SCIENCE BUILDING

LOS MEDANOS COLLEGE

DSA SUBMITTAL DOCUMENTS
NOVEMBER 15, 2004

SCIENCE BUILDING
LOS MEDANOS COLLEGE
Contra Costa Community College District

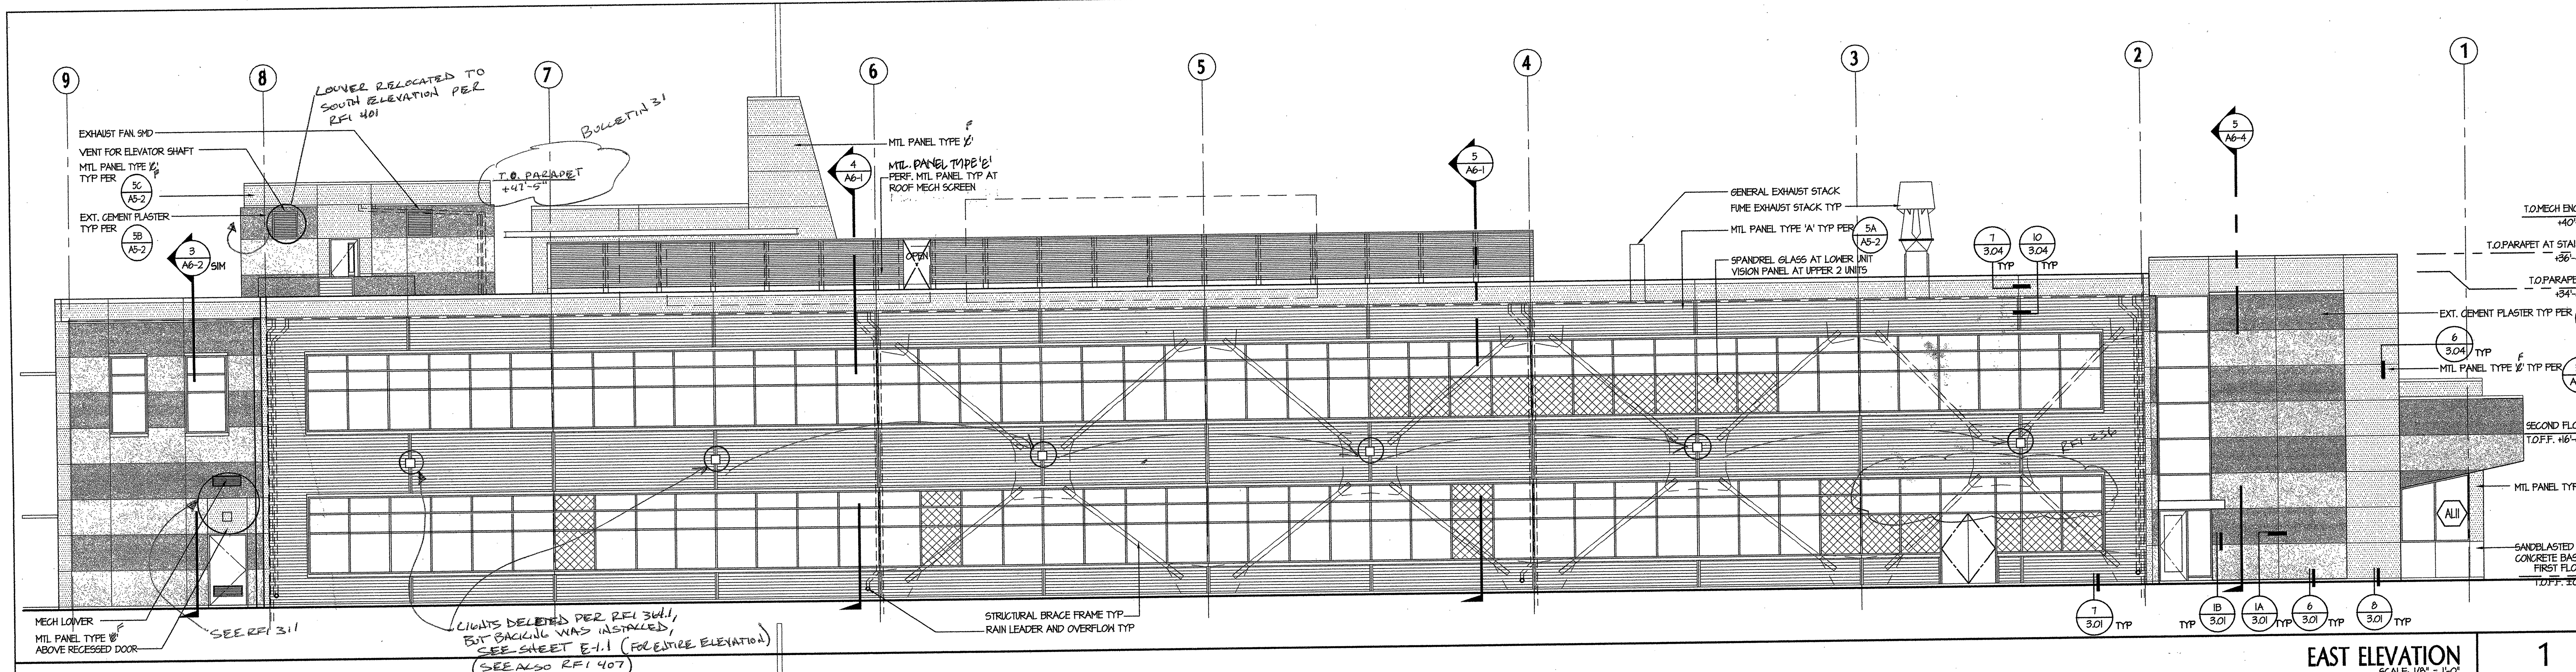
Refer to Drawings A4-1, A4-2, Elevations: Provide Metal panel Type F in lieu of Metal Panel Type C in all conditions where Type C is referenced. ADDENDUM No. 3

LMC SCIENCE 313-023-112.01-0-00.00
drawing no:
A4-1

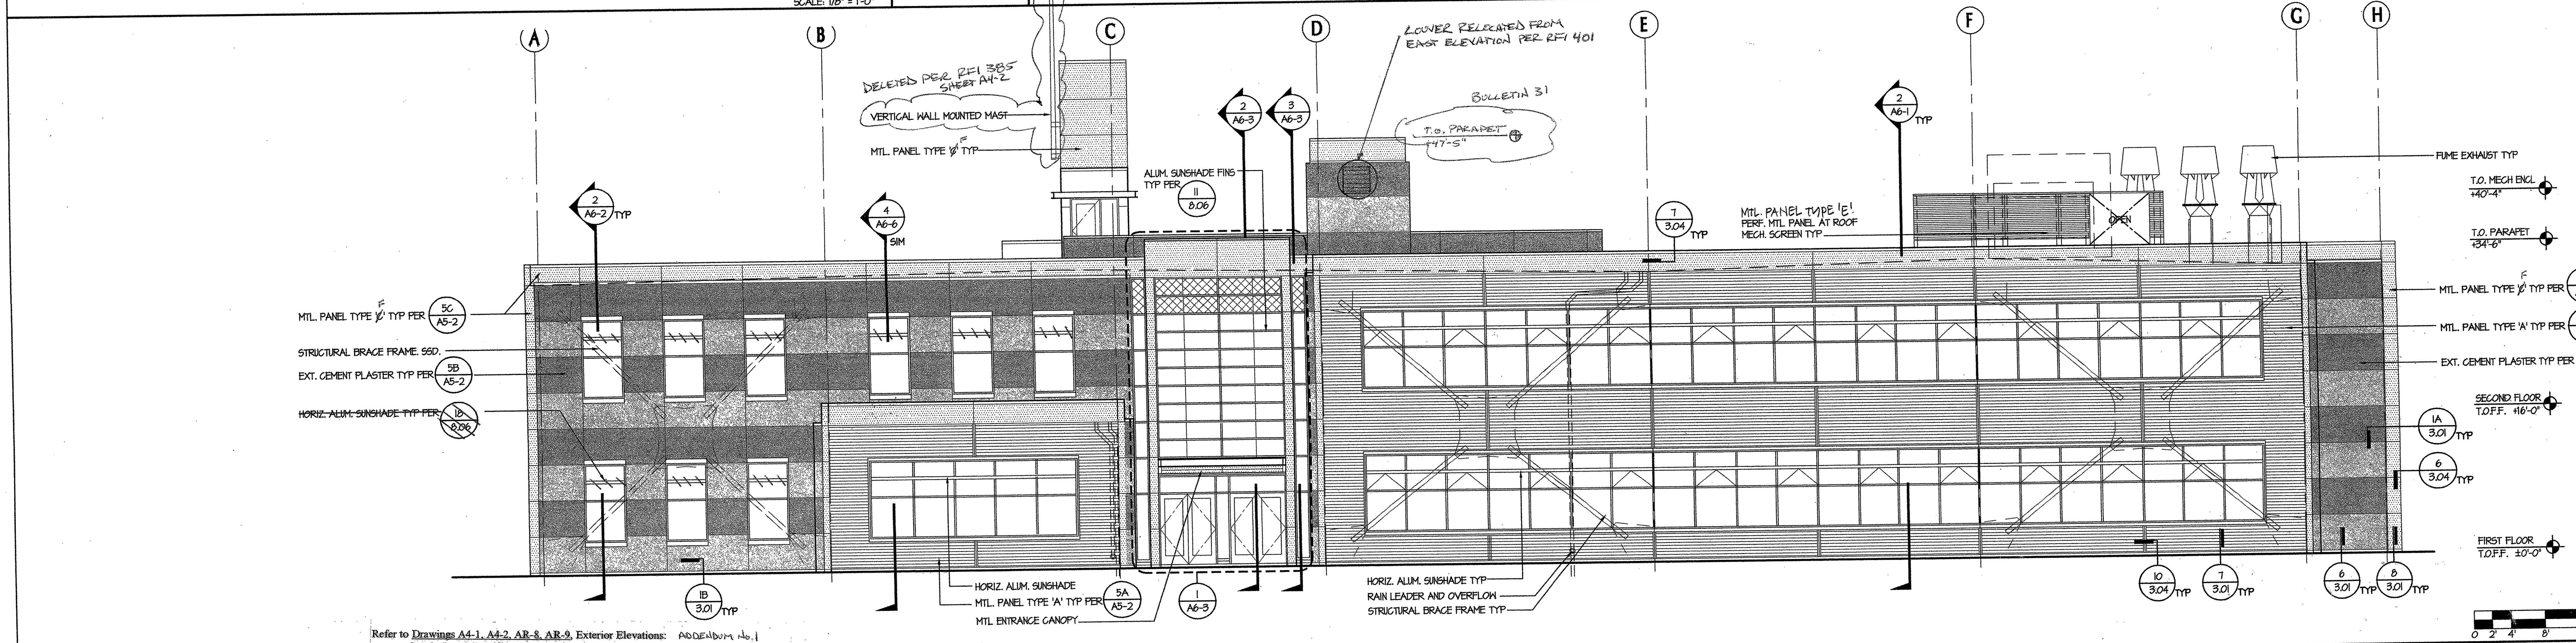
Refer to Drawings A4-1, A4-2, AR-8, AR-9, Exterior Elevations: ADDENDUM No. 1
a. Sunshades at nine (9) windows on south elevation between grid lines A and C shown on A4-1 are deleted.

BUILDING SECTION 4
SCALE: 1/8"=1'-0"

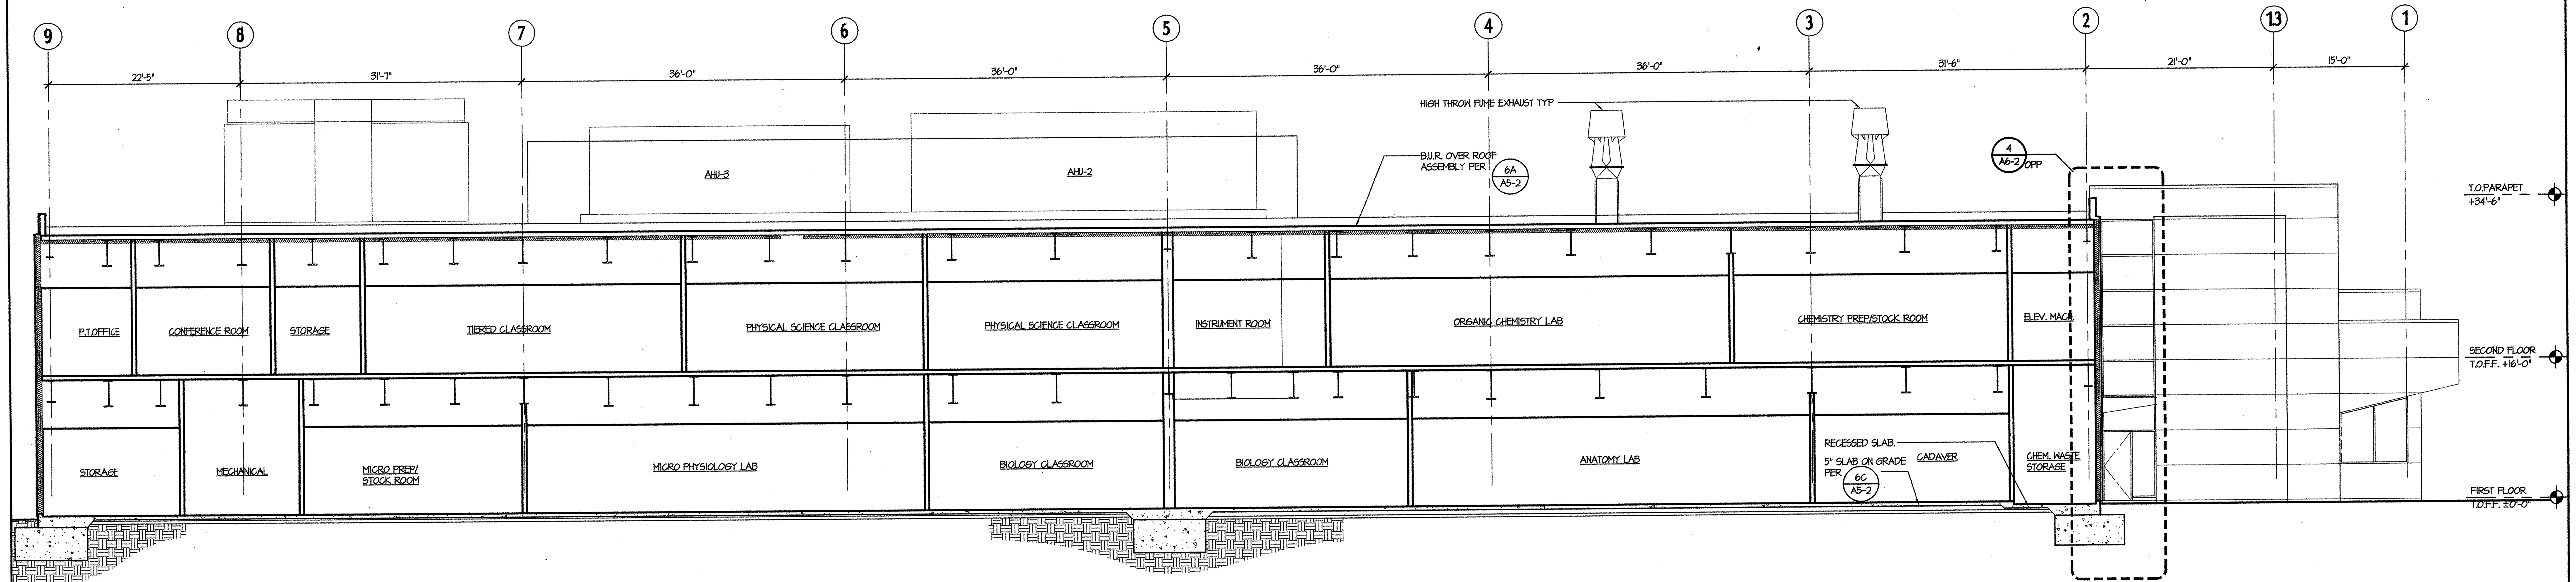
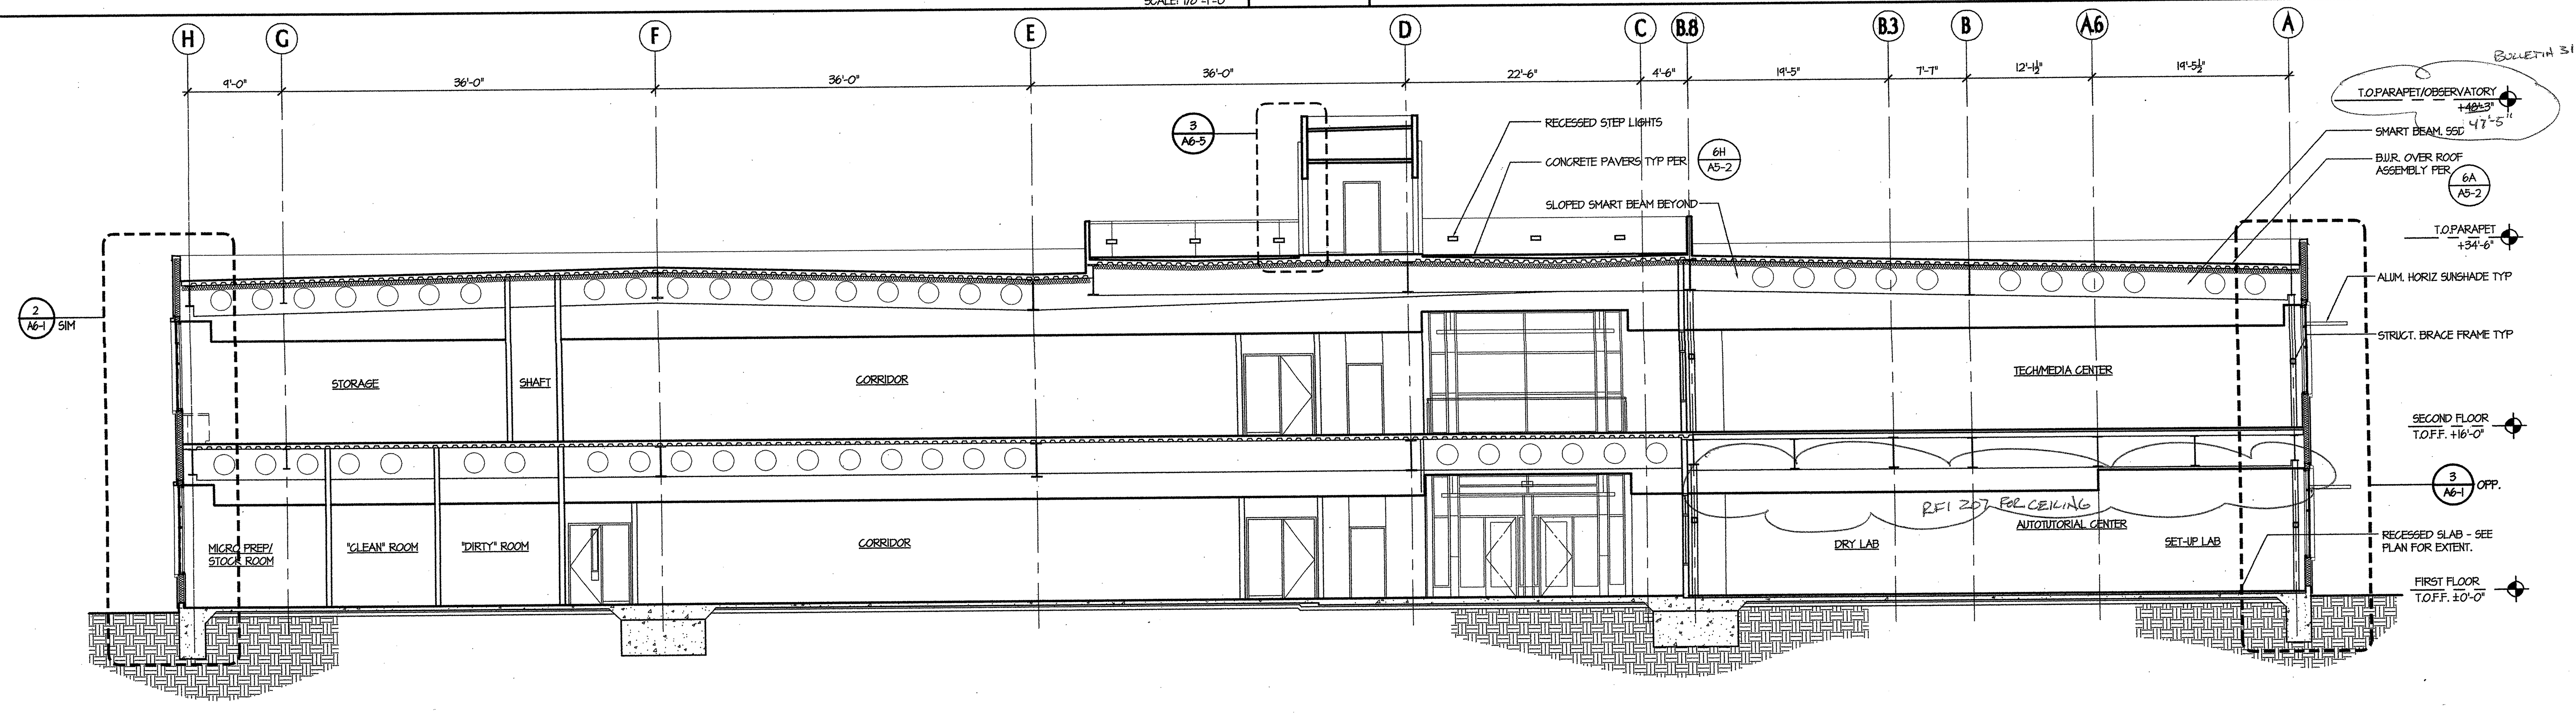
BUILDING SECTION 4/A5-1
REVISED PER RFI #207 5.05.06

STAIR #1 - SECTION 4
SCALE: 1/4" = 1'-0"

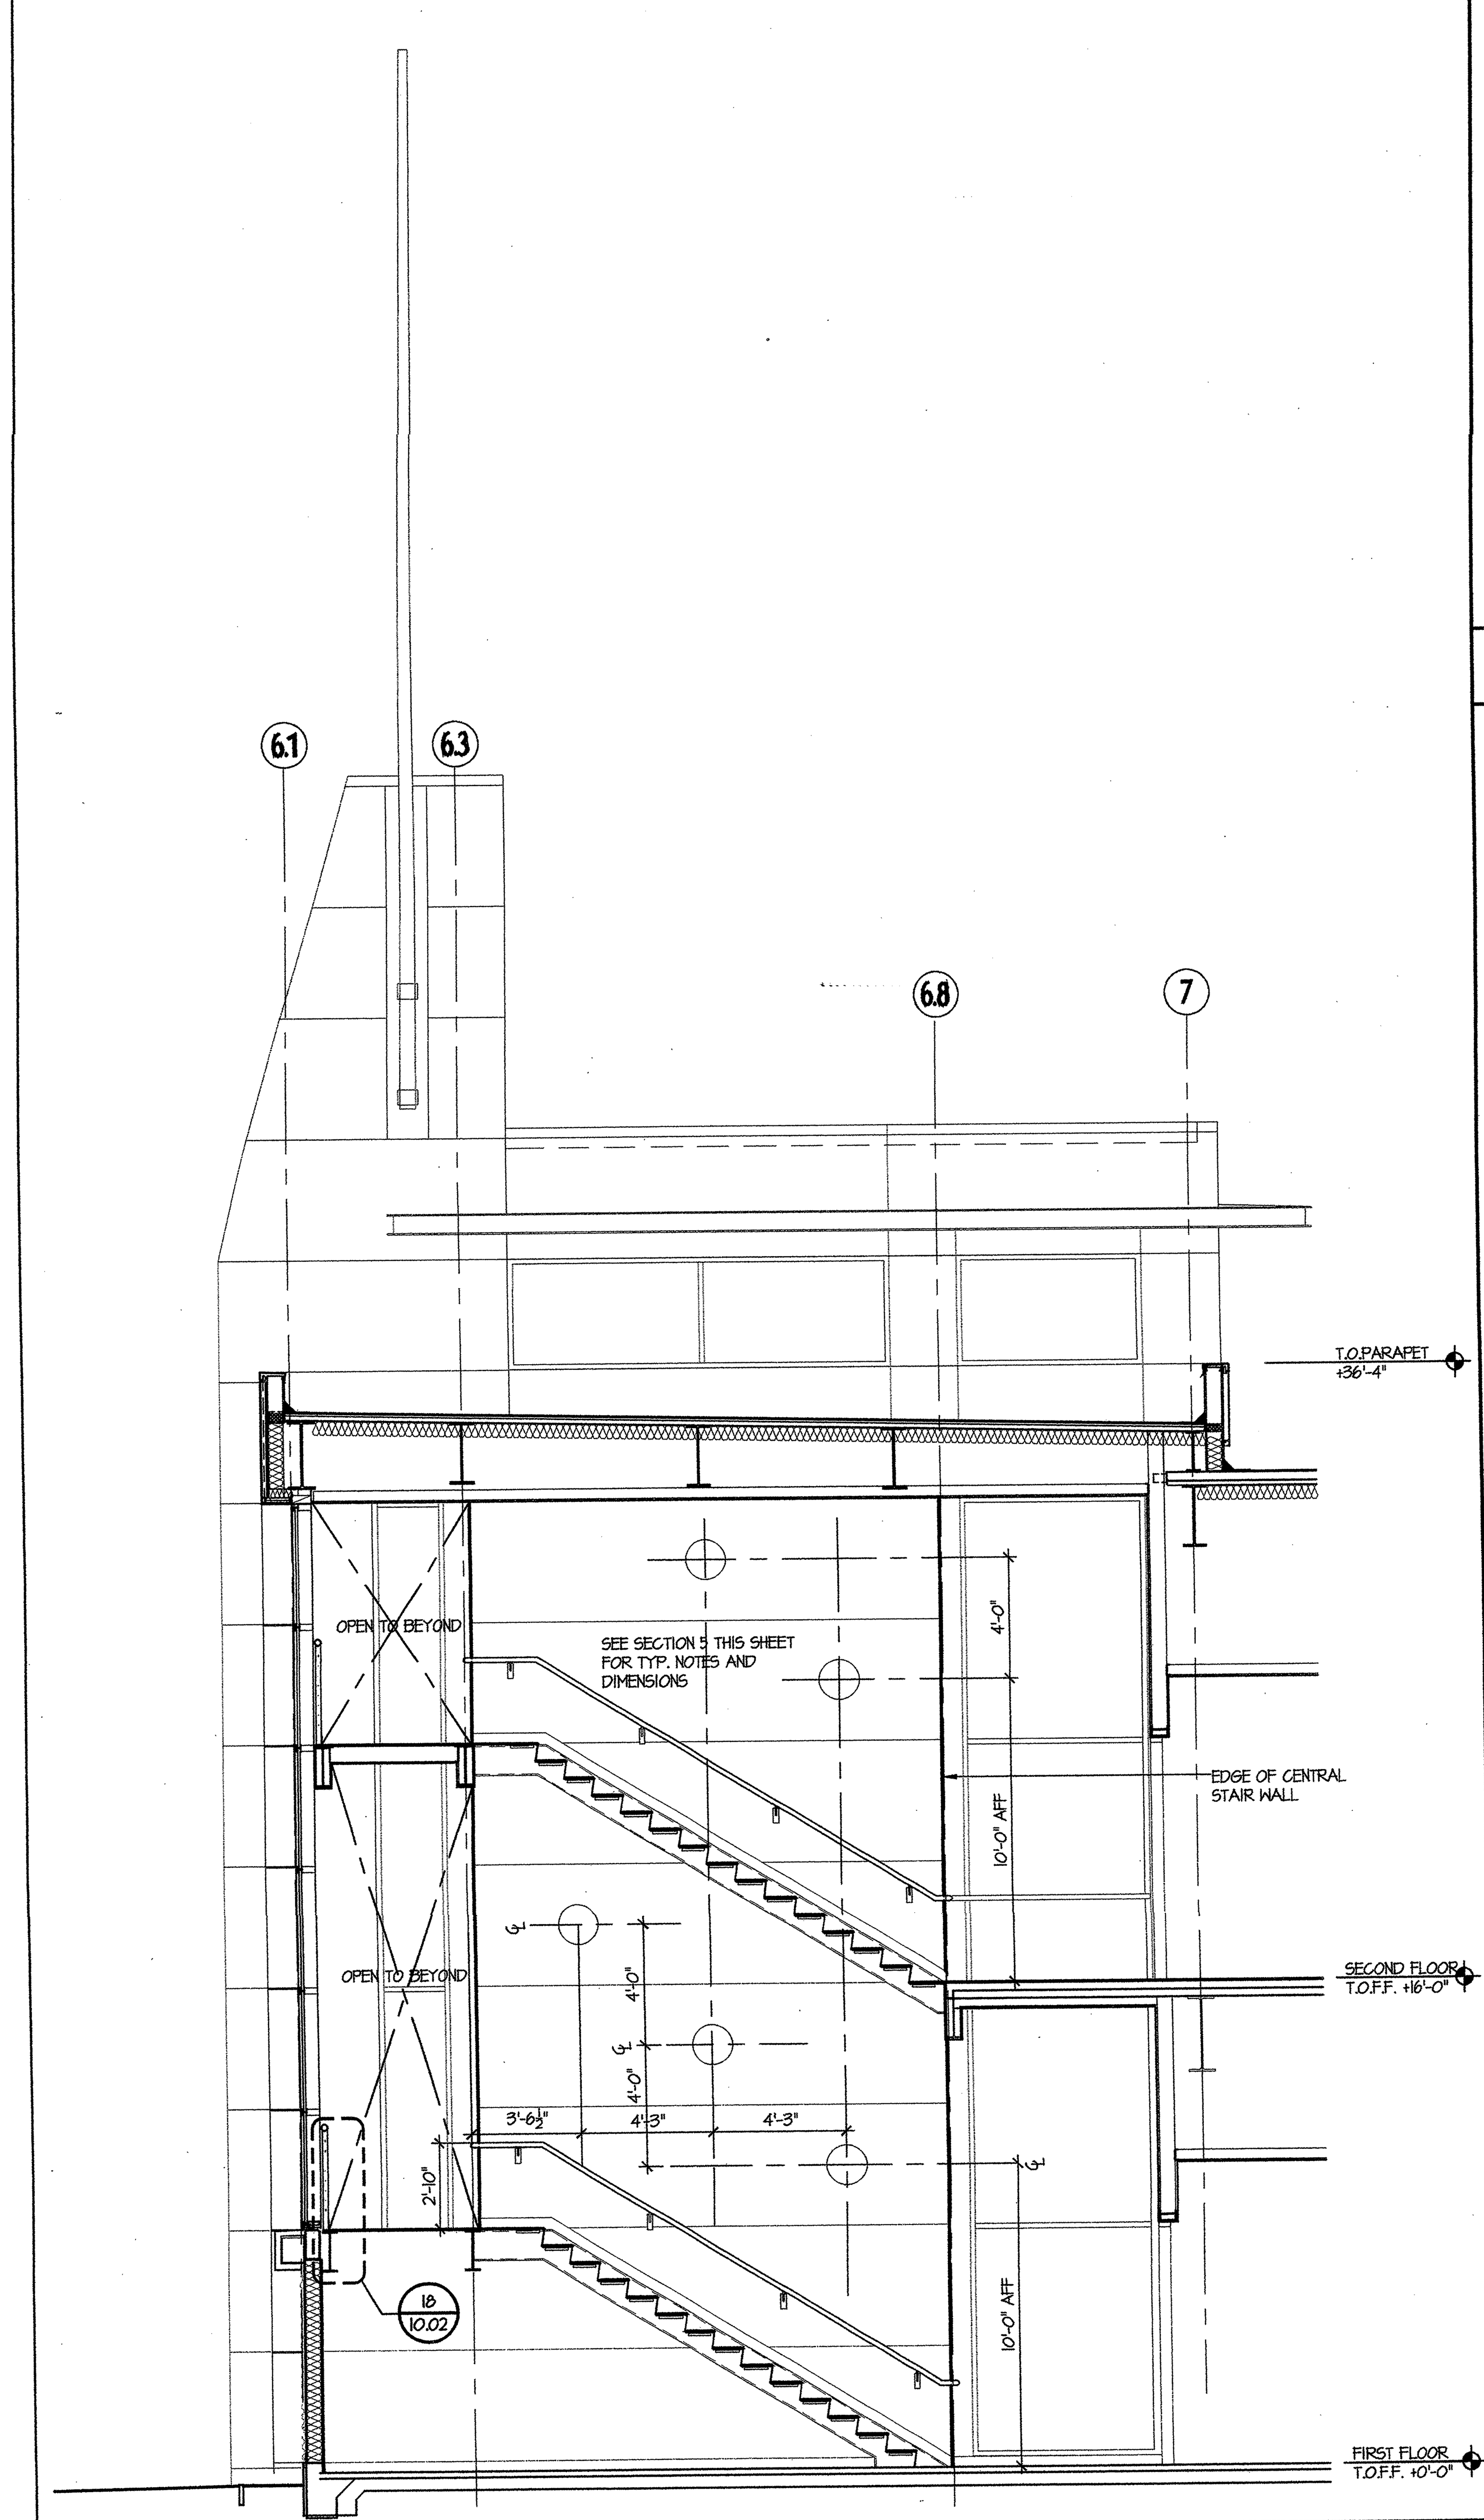
LIGHTING CHANGED PER BULLETIN 51, SHEET E1.1
